DOC16/338445-04
08_0150 MOD 2

BULLI SEAM OPERATIONS PROJECT MODIFICATION (08_0150 MOD 2)

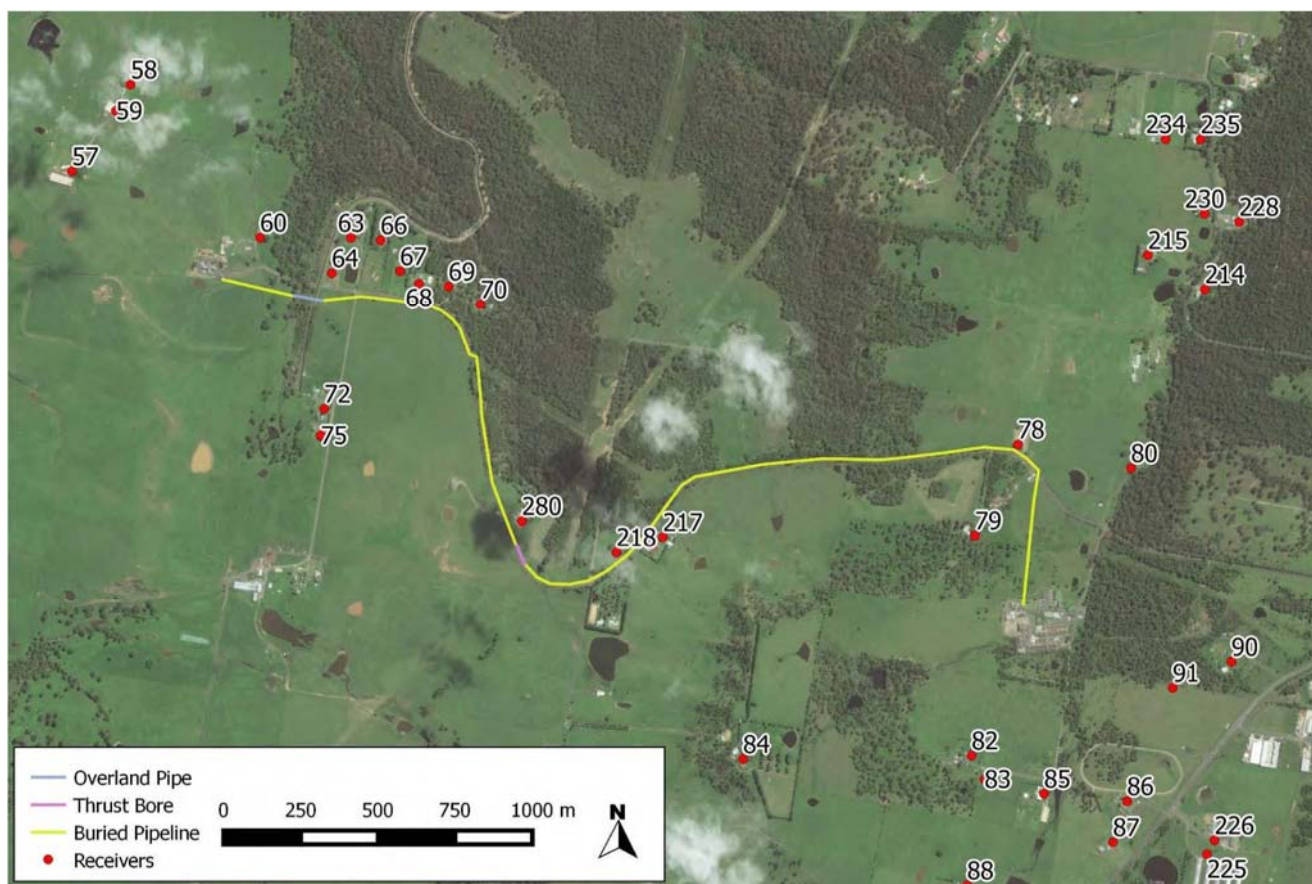
- In relation to noise, table 5.1 of the Wilkinson Murray noise report predicts that two residential noise receptors at locations 78 and 218 are likely to be highly noise affected >75 dBA. Receiver 78 will experience the highest noise levels of 82 – 86 dBA for a period of up to a week. Receivers 218 and 280 are expected to experience high noise levels (RBL + 10 dBA) over a 6 week period during excavation, boring and refilling. For reference, please see Figure 3-1 below taken from the report.

- Noise mitigation proposed for site 78 is to turn off or move any unnecessary equipment away from the site. No mitigation measures are listed for sites 218 or 280.
- The Interim Construction Noise Guideline (ICNG) states that where receivers are likely to be highly noise affected, the proponent must examine reasonable and feasible work practices and mitigation measures to minimise noise.
- The EPA recommends that the proponent revisit planned work practices to identify more significant measures to minimise noise impacts on residents at the affected locations 78, 218 and 280 (see Section 6 of the ICNG).
